UNITED STATES PATENT AND TRADEMARK OFFICE

APPLICATION NO.	FILING DATE	FIRST NAMED INVENTOR	ATTORNEY DOCKET NO.	CONFIRMATION NO.
10/074,486	02/12/2002	Sven Shurm	13071.IUS01	7322

Office Action Summary	Application No.	Applicant(s)
	10/074,486	STURM ET AL.
Examiner	Art Unit	
John K. Fristoe Jr.	3754

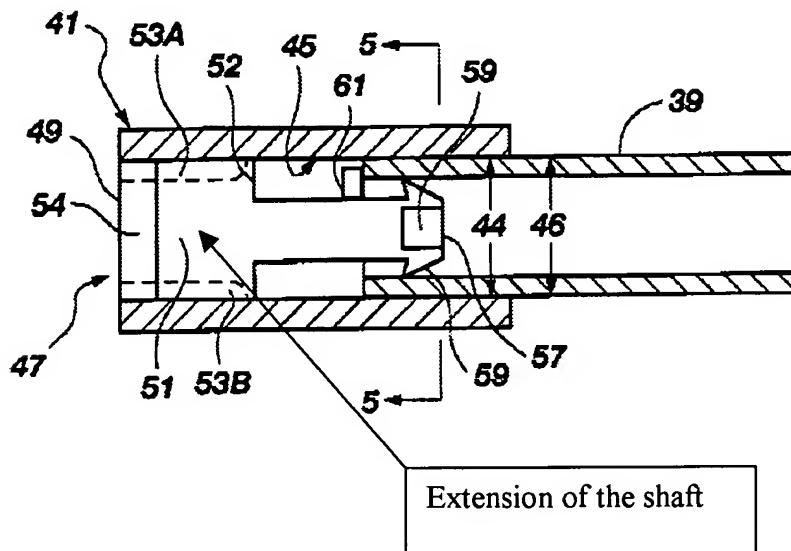
4. Claims 1-6, 11, and 14-18 rejected under 35 U.S.C. 102(b) as being anticipated by U.S. Pat. No. 5,971,357 (Denton et al.). Denton et al. discloses an orally activated fluid dispensing system comprising a fluid source having a fluid reservoir (31), a fluid line (39), an orally activated valve (41) comprising a housing (43), a valve member (47) including an opening (53A, 53B), the housing (43) and valve member (47) creating a flow path, an actuating mechanism including a deformable seal (45) being deformable about the valve member (47), the actuating mechanism having a fluid tight seal preventing fluid flow in a normally closed position (fig. 2, fig. 3) and being actuatable into an open position (fig. 8, fig. 9) to enable fluid flow though said flow path when said sidewall of the housing is deformed, the housing (43) including a chamber

(55), a plurality of ribs (wall members created by 53A and 53B) within the chamber (55), the ribs (wall members created by 53A and 53B) are commonly connected through a shaft portion (51, as seen in the following picture):

wherein the deformable seal of the actuating mechanism including a sealing structure (45), a seal member (54) disposed at the second end of the valve and cooperating with the sealing structure (45) wherein the sealing structure including a resilient material with a pre-load enabling the sealing structure to releasably stretch about the sealing member (col. 2, lines 5-8), in the open position including at least one opening defined by deformation of the sidewall (fig. 8, fig. 9), wherein the first axis is pressed by an applied oppositely disposed forces (65A, 65B), wherein the oppositely opposed forces are a squeeze force (col. 1, lines 65-66), and wherein the valve is a rigid plastic member (col. 4, lines 4-8).
